**MINERALS PROGRAM INSPECTION REPORT**  
**PHONE: (303) 866-3567**

<b>MINE NAME:</b> Uncompahgre Pit	<b>MINE/PROSPECTING ID#:</b> M-2013-007	<b>MINERAL:</b> Gravel and sand	<b>COUNTY:</b> Montrose
<b>INSPECTION TYPE:</b> Monitoring	<b>WEATHER:</b> Clear	<b>INSP. DATE:</b> February 28, 2024	<b>INSP. TIME:</b> 10:30
<b>OPERATOR:</b> Lazy K-Bar Land & Cattle Company, LLLP	<b>OPERATOR REPRESENTATIVE:</b> Zane Luttrell	<b>TYPE OF OPERATION:</b> 112c - Construction Regular Operation

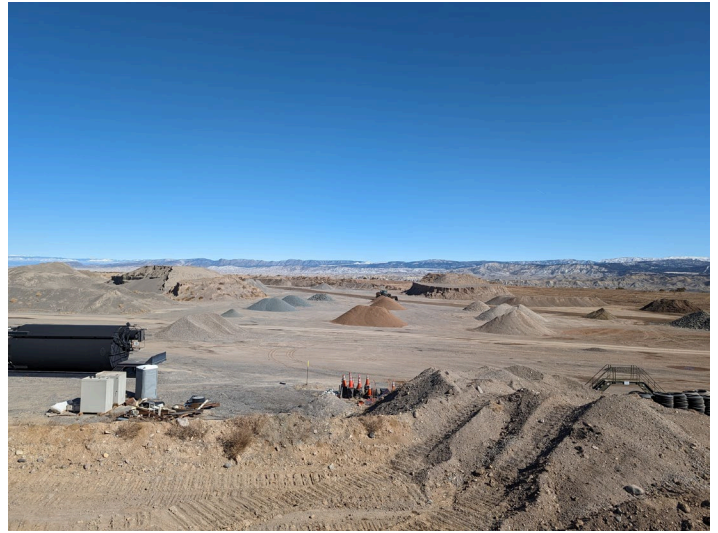
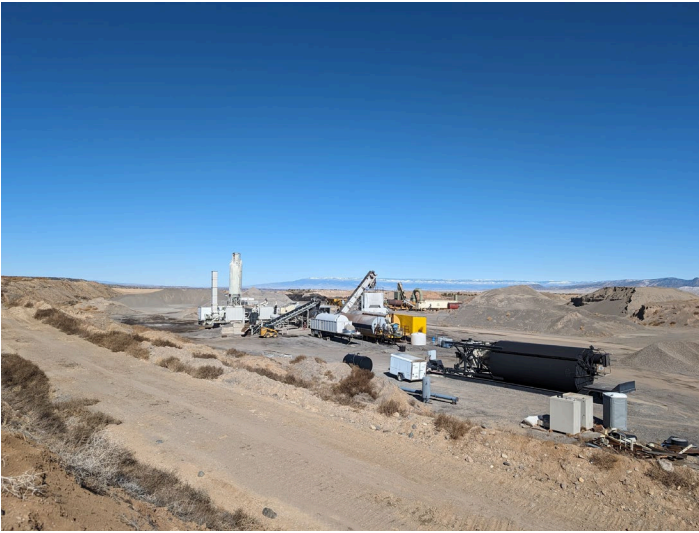
**PROBLEM:** Operator has deviated from approved mining/reclamation plan. The approved plans require concurrent reclamation so that the disturbed pit area is limited to approximately 16 acres. Concurrent reclamation has not taken place and the current disturbed pit area is approximately 75 acres. Because of this, the financial warranty is insufficient.

**The operator has deviated from the approved mining/reclamation plans which require concurrent reclamation so that the maximum disturbed pit area would be limited to approximately 16 acres. Concurrent reclamation has not taken place and the current disturbed pit area is approximately 75 acres. Because of this, the financial warranty is grossly inadequate. This has been noted as a problem and a Notice of Financial Warranty increase will be sent to the operator under separate cover.**

**CORRECTIVE ACTIONS:** The operator will be notified under separate cover of a financial warranty increase.
